**Amendments to the
Cascade Station/Portland
International Center Plan District**
Amendments to Title 33, Planning and Zoning

Ordinance No. 179076
Adopted February 17, 2005

Amendments to Chapter 33.508, Cascade Station (CS)/Portland International Center (PIC) Plan District and New Section 33.807, CS/PIC Transportation Impact Analysis

Figure 508-1014
Environmental Zone Subareas

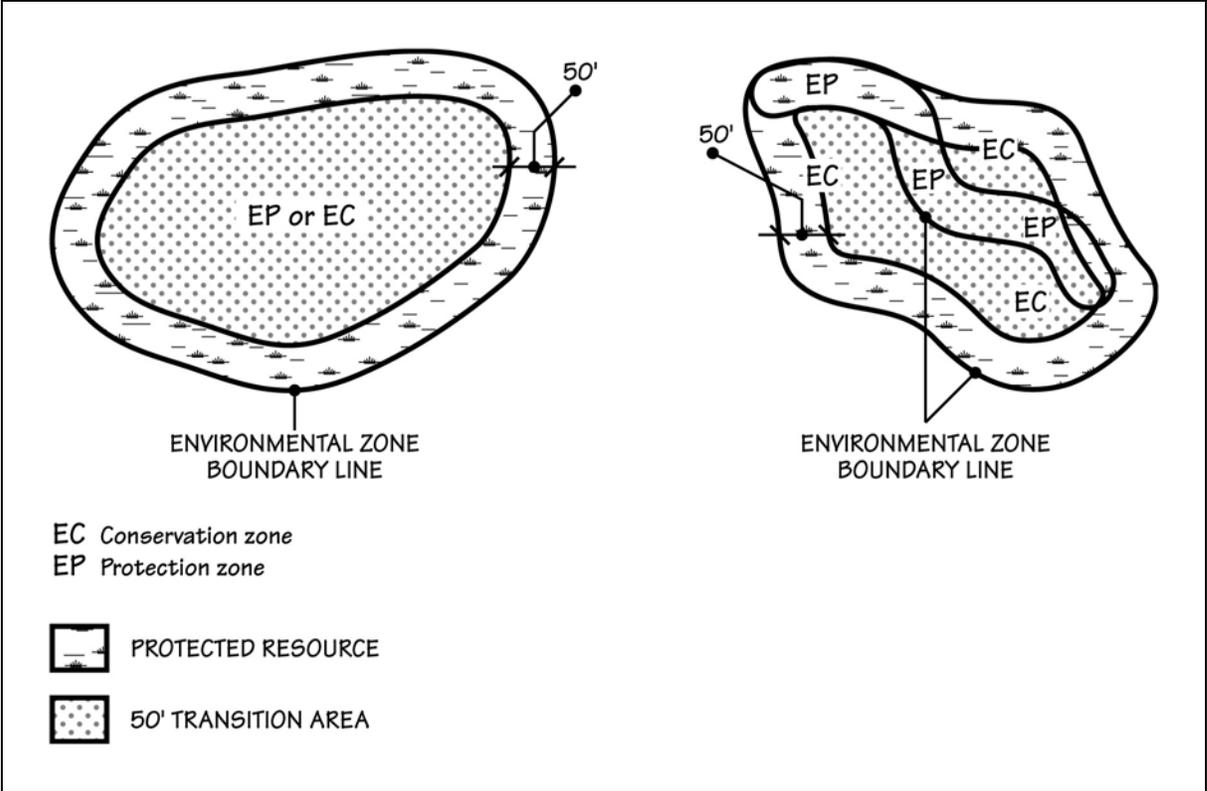
Figure 508-10 replaced with Figure 508-14 shown below

Section 4: Zoning Map Corrections

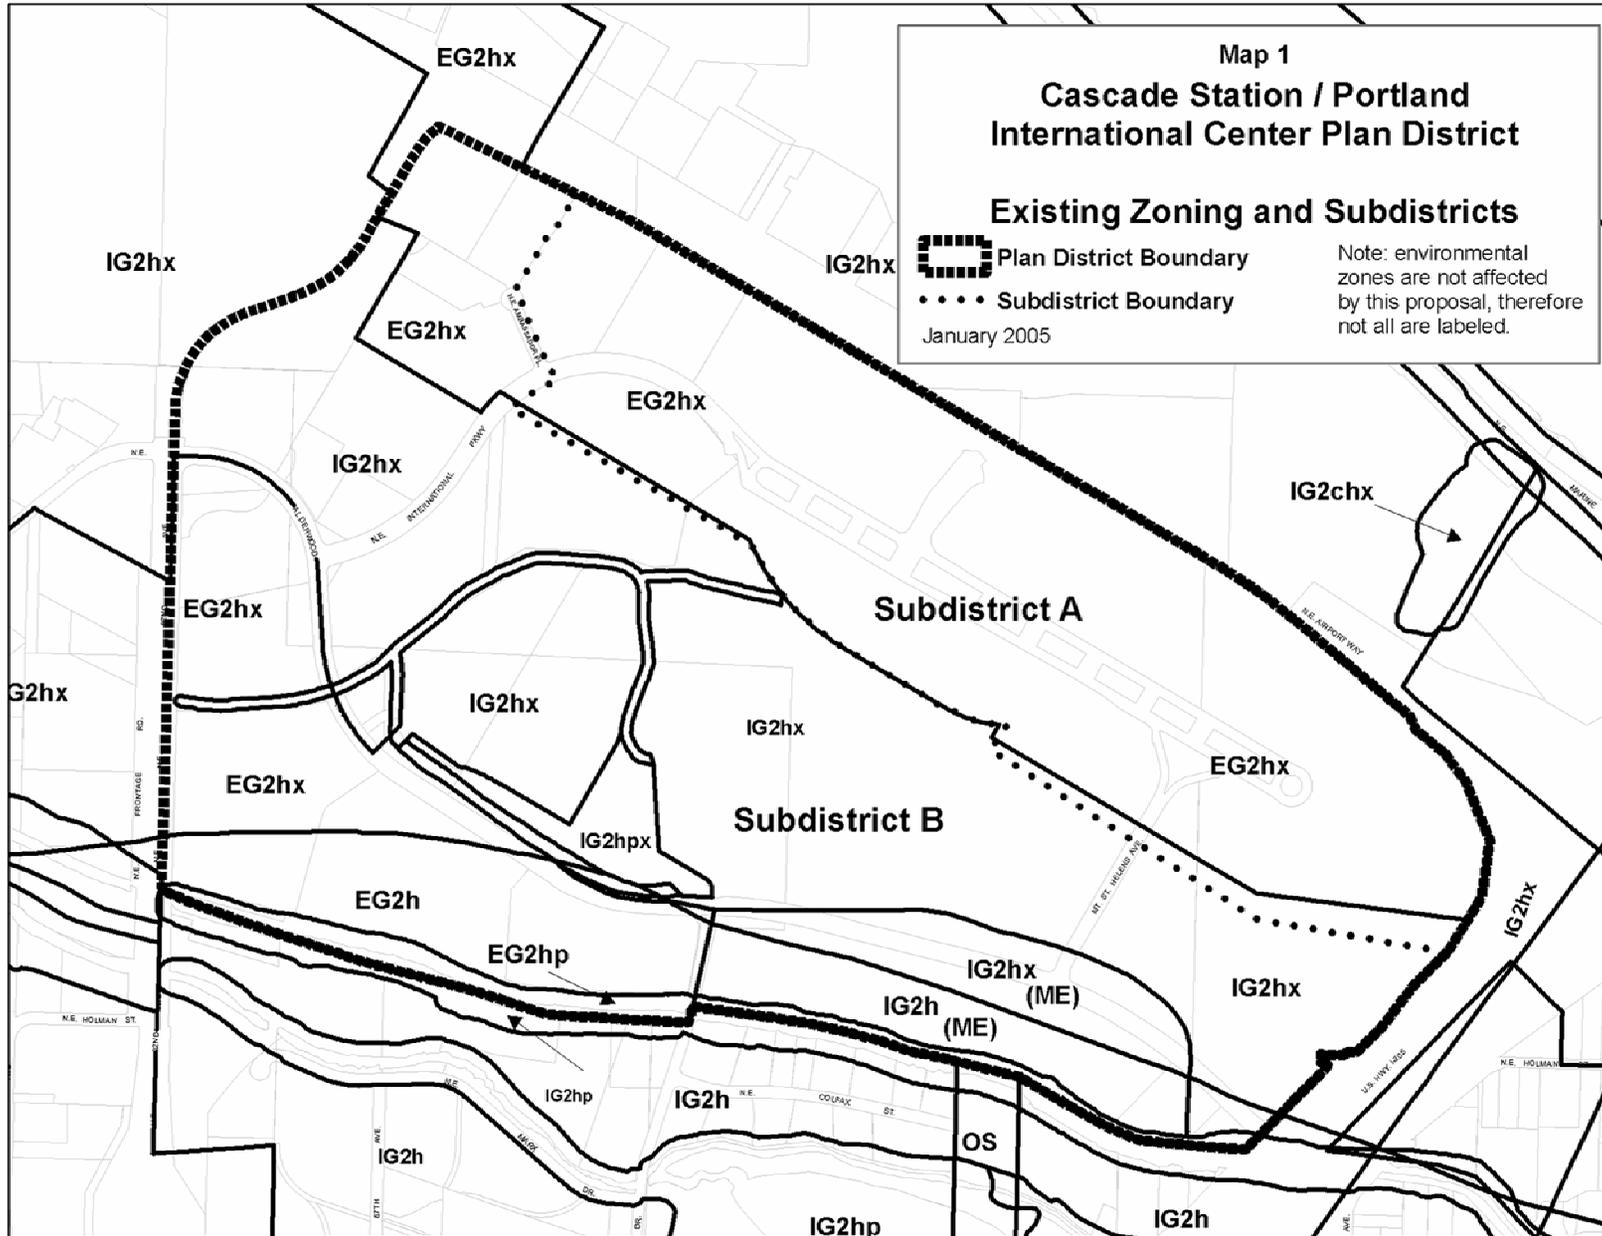
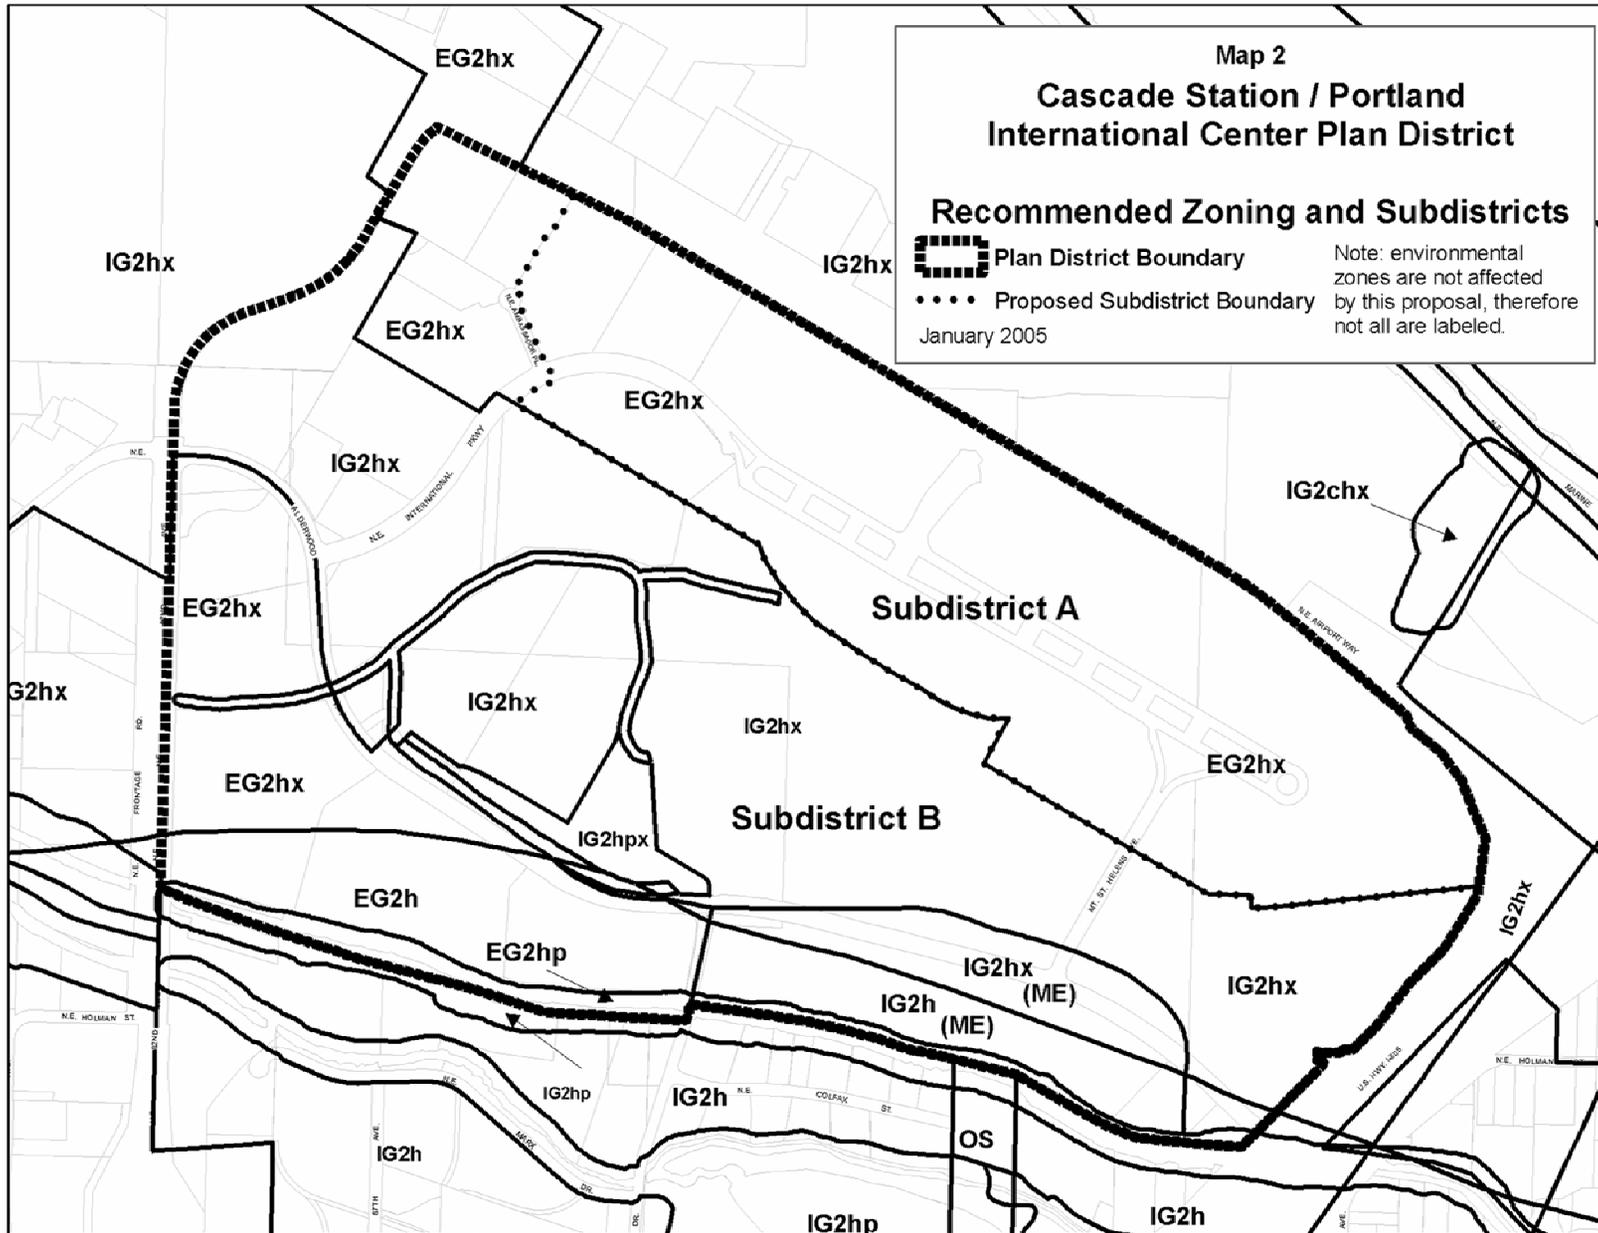
Section 4 of this report illustrates amendments to correct a mapping misalignment between base zone and plan district boundaries. A recent survey and legal

description for Subdistrict A was used to reconcile the zoning and plan district boundaries.

As stated in the introductory section of this report, Planning staff realized that base zone and plan district boundaries were not in alignment and that there were a few minor discrepancies with these delineations as represented on City GIS maps. Staff researched this issue with assistance from the Port of Portland, the owner of Cascade Station/PIC land. The Port provided Planning staff with a recent survey and legal description for Subdistrict A, which was used to reconcile the base zone and plan district overlay boundaries.
